1 REVISED PER ADDENDUM NO. 2 DATED MARCH 3, 2011

ROUTES 65 & 80 BRIDGES
GENERAL PLAN NO. 3

1 **REVISED PER ADDENDUM NO. 2 DATED MARCH 3, 2011**

GENERAL PLAN NO. 4

WEST CAPITAL AVENUE UNDERCROSSING

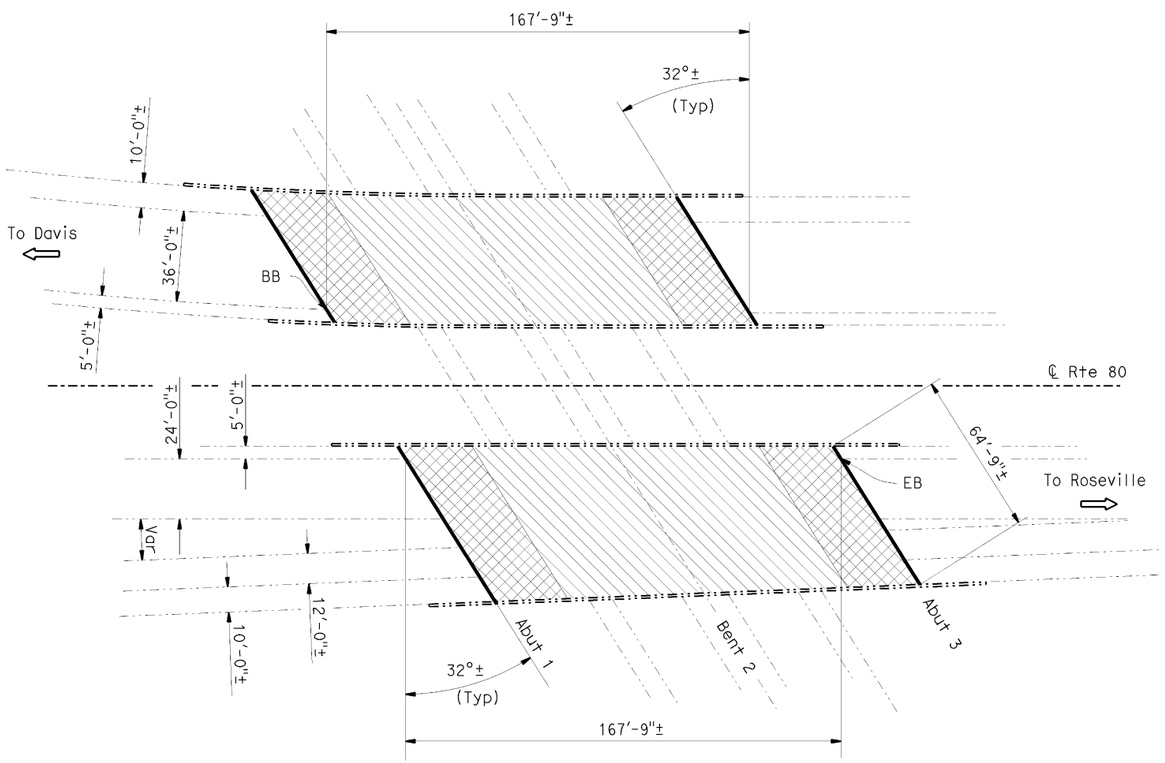
Indicates limits of remove AC Surfacing prepare bridge deck surface, furnish and place new ¾" minimum depth polyester concrete overlay. Prior to placing new polyester concrete overlay remove unsound concrete and patch with rapid setting concrete as shown on the "DECK OVERLAY DETAIL".- on JOINT SEAL DETAILS NO. 2 sheet. REMOVE AC SURFACING AREAS INCLUDE 3' WIDE, FULL LENGTH AREAS, AT THE FACES OF BARRIERS, IN ADDITION TO OTHER RANDOM AREAS THROUGHOUT THE DECK.

LAKE WASHINGTON OVERHEAD

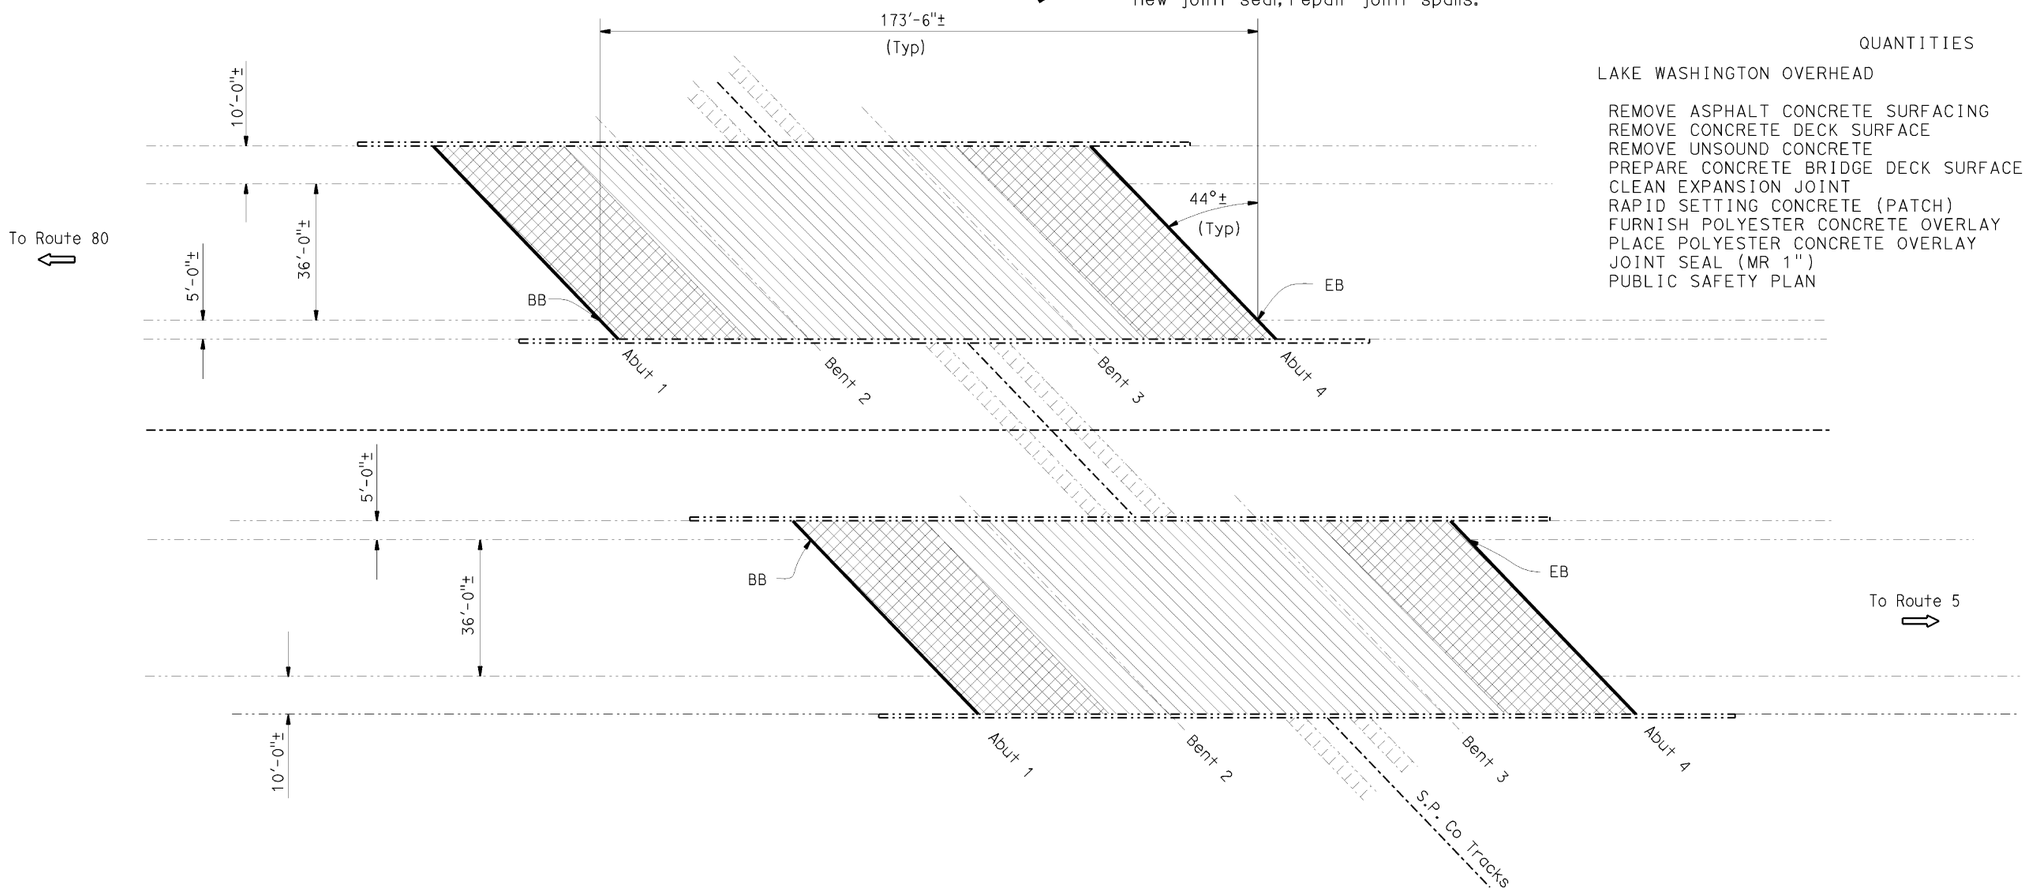
Indicates limits of remove AC Surfacing prepare bridge deck surface, furnish and place new ¾" minimum depth polyester concrete overlay. Prior to placing new polyester concrete overlay remove unsound concrete and patch with rapid setting concrete as shown on the "DECK OVERLAY DETAIL".- on JOINT SEAL DETAILS NO. 2 sheet. REMOVE AC SURFACING AREAS INCLUDE 3' WIDE, FULL LENGTH AREAS, AT THE FACES OF BARRIERS, IN ADDITION TO OTHER RANDOM AREAS THROUGHOUT THE DECK.
